## TR-150 Adequacy Response

**Re: West Elk Mine (Permit No. C-1980-007)  
Technical Revision No. 150, (TR-150)  
Initial Adequacy Review**

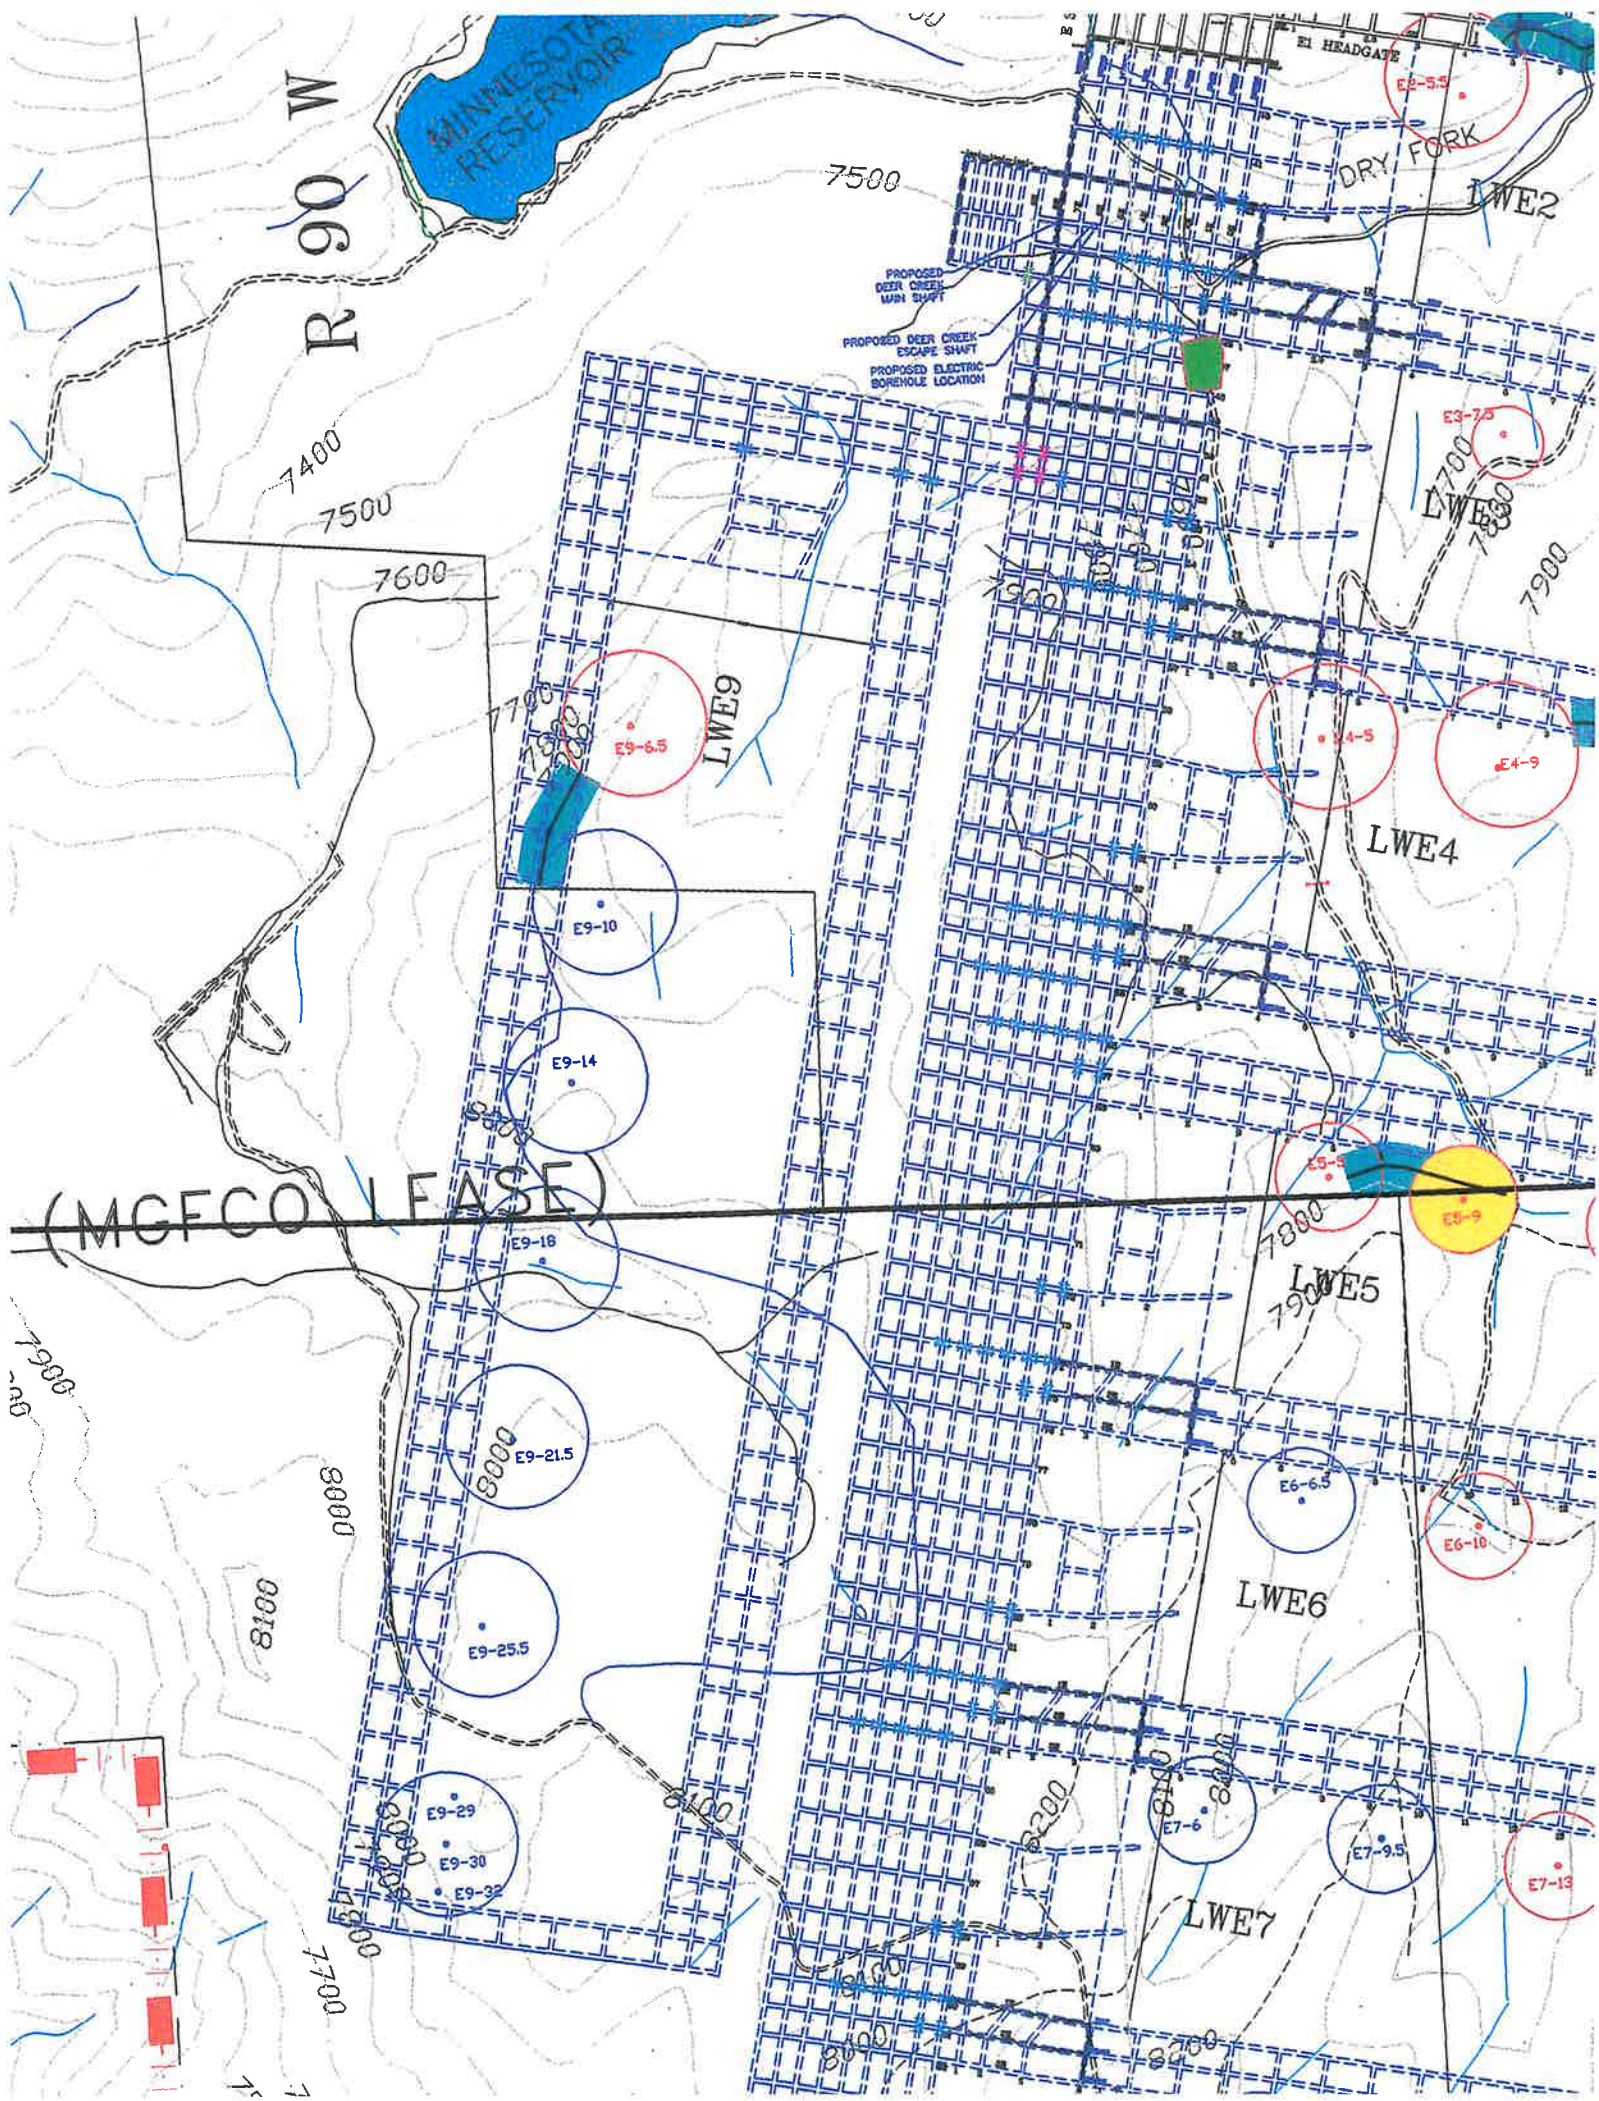
2. *The proposed revised text on Page 2.05-121 states that:  
Monument Dam and Minnesota Reservoir are located outside of the angle of mining influence of the eleven longwall panels (panel LWE1 through LWE17) within the South of Divide mining area...*

*Please rephrase the text to clarify exactly which panels are referred to in the statement*

3. *Later in the same paragraph the text states that the angle from the northern edge of the LWE16 and LWE17 panels to the reservoir is 69°. This is the same as the angle previously stated for LWE9, which was projected to end ~1400' south of the projected boundary of LWE16/17.*

*Please recalculate the angle between the proposed longwall panels and Minnesota Reservoir and verify the assertion that it is much greater than the estimated angle of draw (19°).*

See Attachment, "Permit Page 2.05-121" for revised language.

Please see same attachment as above, "Permit Page 2.05-121" for revised angle of draw from LWE17, which is the close area to Monument Dam.

Monument Dam and Minnesota Reservoir are located outside of the angle of mining influence of the eleven longwall panels (panels LWE1-8, SST1-4, LWE10-12 and LWE15-17) within the South of Divide mining area (see Map 51). The northern portions of panels LWE16 and LWE17, which are nearest to the reservoir, are located several hundred feet away. The angle of draw to this nearest area of mining is 79°. The angle is much greater than the maximum of 19° projected for the SOD mining area. This means that Minnesota Reservoir will not be affected by longwall mining in projected panels LWE16 and LWE17.
